15 Lyndhurst Terrace  
Belsize Park  
NW3 5QA

## Refurbishment and Extension of Existing Dwelling

Brick corbelling to en suite but of only 15mm projection

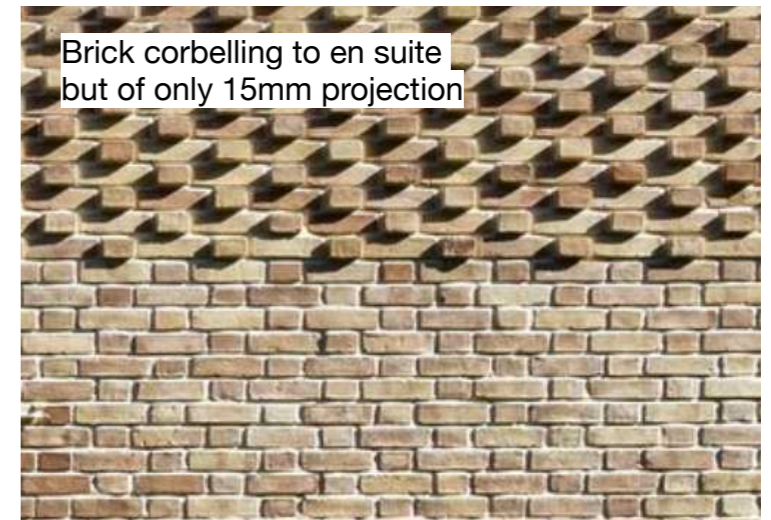
Side extension brickwork pattern has been revised during the course of the pre-app to tone it down, which is also welcomed.

- We have significantly reduced the projection from 50 - 60mm to just 15mm and are utilising a matching brick for a subtle hint of the new adjoining the original and differentiation of extension

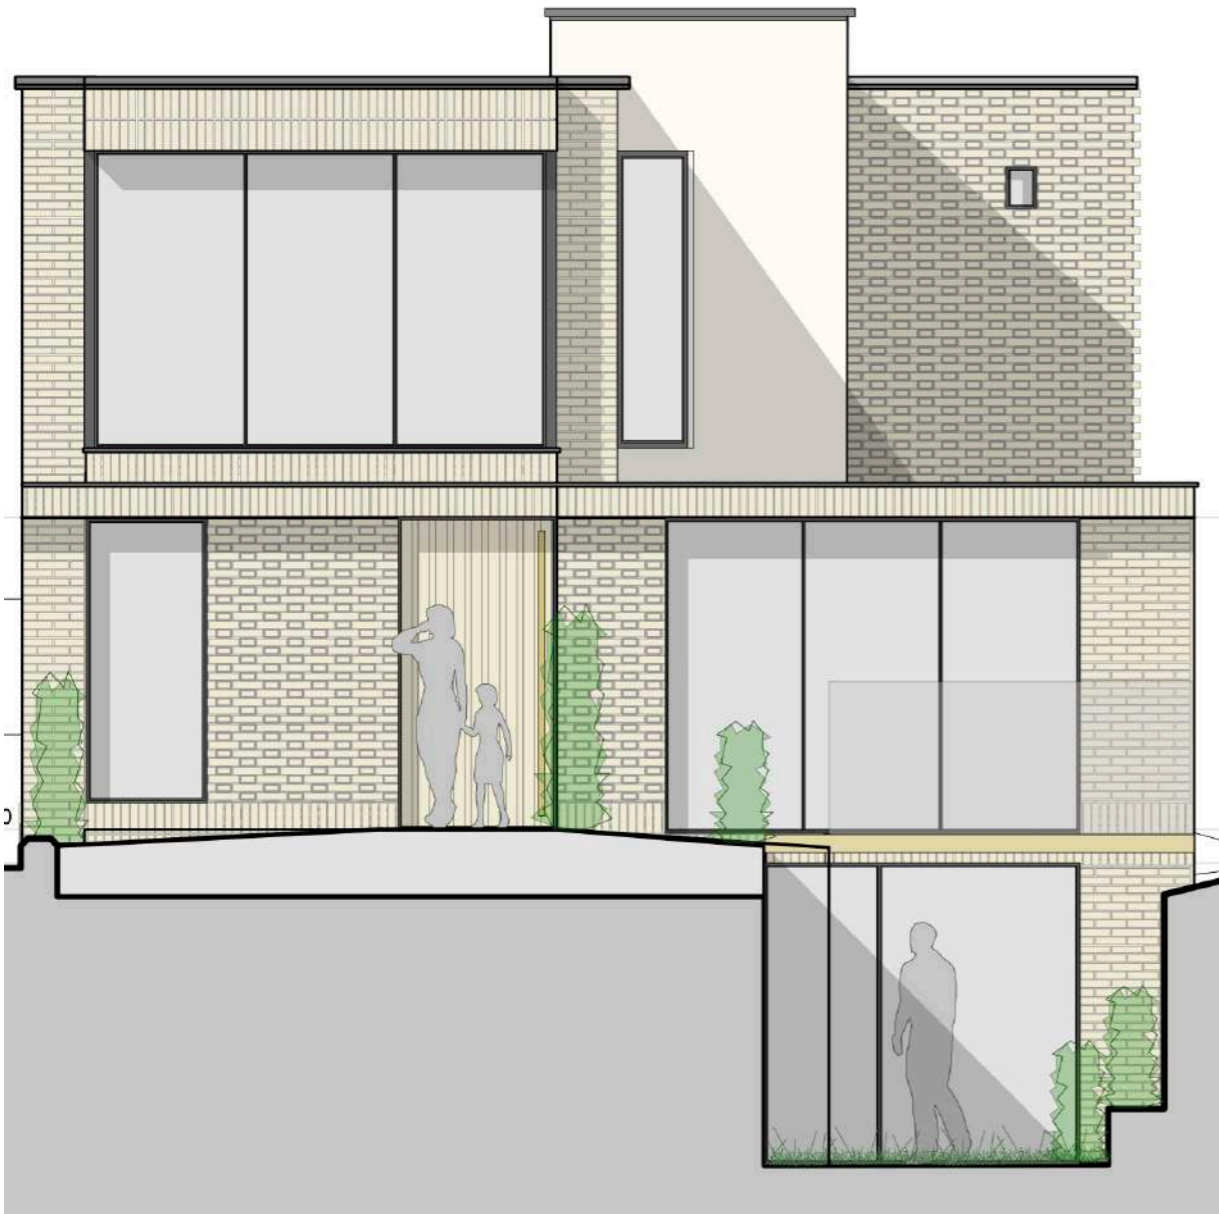
Front details submitted for pre application consultation

Front details following pre application evolution and discussions with changes made as recommended by the Camden planning team
